UNITED STATES PATENT AND TRADEMARK OFFICE

10/710,253

Office Action Summary	Application No. 10/710,253	Applicant(s) HOHMANN ET AL.	
	Examiner Katherine W. Mitchell	Art Unit 3677

DETAILED ACTION

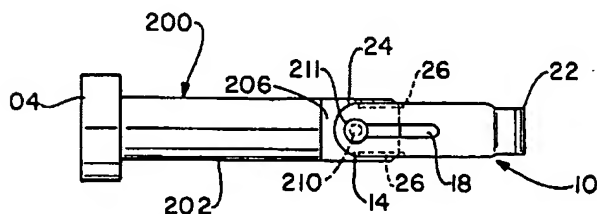
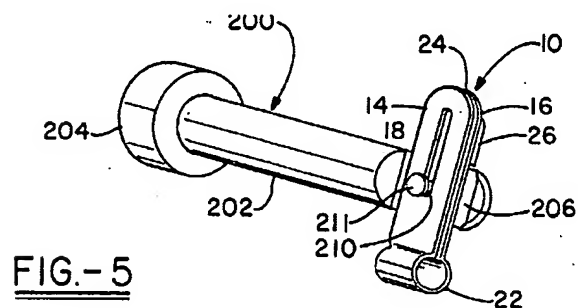
8. Claims 27-29 are rejected under 35 U.S.C. 102(b) as being anticipated by Modrey USP 3279302.

Modrey teaches an integrated pin and clip, comprising a shaft 6 with a locking member 4 at a first end of said shaft, with the locking member movable between a 1st position and a 2nd position wherein the locking member 4 is generally coaxial with said shaft in 1st position (Fig 2) and perpendicular to said shaft in said 2nd position (Fig 3), and a retaining means (cam/sleeve/pin interaction, col 2 lines 9-52 and col 4 lines 5-64), such that compressive force and its release secures the locking member in said first position and said 2nd position. In this case, 2nd position is the intermediate position

shown in Fig 3, where the locking member extends from only one side of the shaft, and in this 2nd position, the locking member is generally perpendicular to the shaft.

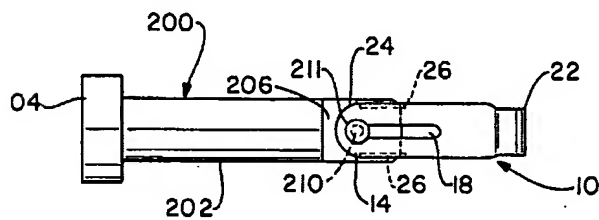
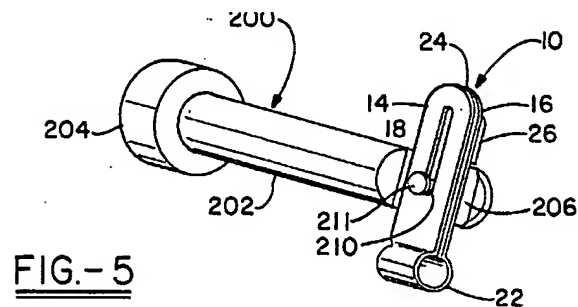
13. Claims 27-31 are rejected under 35 U.S.C. 103(a) as being obvious over Collister USP 5507611.

Collister teaches an integrated pin and clip, comprising a shaft 202 with a locking member at a first end of said shaft, with the locking member movable between a 1st position that is *generally* coaxial with the shaft member and a 2nd position that is perpendicular to the shaft member, a retaining means (spring action such that locking member acts like tweezers with retaining wings 26, such that compressive force and its release secures the locking member in said first position and said 2nd position.

However, Collister fails to teach that the locking member extends from only one side of the shaft. Absent some showing of criticality, the claimed shapes are nothing more than several of numerous shapes a person of ordinary skill in the art would find obvious for the purpose of providing a locking pin to a shaft. In re Dailey 149 USPQ 47 (CCPA 1976). Further, changes in size or shape without special functional significance are not patentable. *Research Corp.v. Nasco Industries, Inc.*, 501 F2d 358; 182 USPQ 449 (CA 7) cert. Denied 184 USPQ 193; 43 USLW 3359 (1974). As long as the end is blocked from being removed from a hole, there would be times when having the locking member extend from only one side would obviously be beneficial to one of ordinary skill in the fastener arts-- when there is insufficient clearance or cramped space, for example.

There is a cut out on the outer surface of the shaft (206) sized to receive the locking member in seating engagement and retain the locking member in the 2nd position. (Fig 5). The locking member is adapted to be pulled out of engagement with the cut out to allow rotation between 1st and 2nd positions.
